# UNITED STATES PATENT AND TRADEMARK OFFICE

APPLICATION NO.	FILING DATE	FIRST NAMED INVENTOR	ATTORNEY DOCKET NO.	CONFIRMATION NO.	
10/765,958	01/29/2004	Hiroshi Takeuchi	MIT-024-USA-P	MIT-024-USA-P 2329	
27955 7	590 10/12/2004		EXAMINER		
TOWNSEND & BANTA			HO, THOMAS Y		
601 PENNSYLVANIA AVE N.W. SUITE 900, SOUTH BLDG			ART UNIT	PAPER NUMBER	
•	WASHINGTON, DC 20004				
			DATE MAIL ED. 10/12/2004

#### **DETAILED ACTION**

FIGURE A (TORAN)

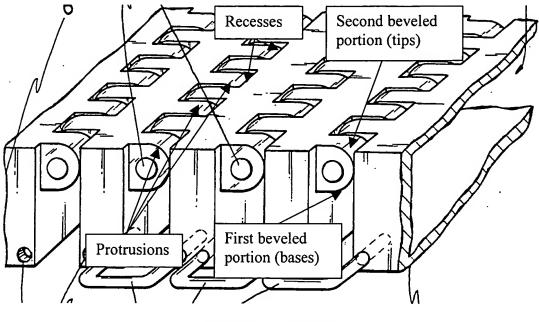
FIGURE A better shows the cited structures of TORAN and is depicted below. While TORAN discloses side by side bars 8, they fail to show the ability to be shortened and extended; while

As to claim 3, TORAN discloses first beveled portions are formed on lower sides at the tips of the connecting protrusions while second beveled portions are formed on the upper sides at the bases of protrusions, to sue the bendable bottom member as a bendable portion between the back region and the waist region. See FIGURE A above.

As to claim 4, TORAN discloses first beveled portions are formed on the upper sides at tips of connecting protrusions, while second beveled portions are formed on lower sides at the bases of protrusions, to use the bendable bottom member as a bendable portion between the waist region and the leg region. See FIGURE A above, but reverse the labels of first and second

As to claim 5, TORAN discloses the second beveled portions at the bases of the connecting protrusions are inclined in adaptation to the desired bending angles with the adjacent bars. See FIGURE A above.
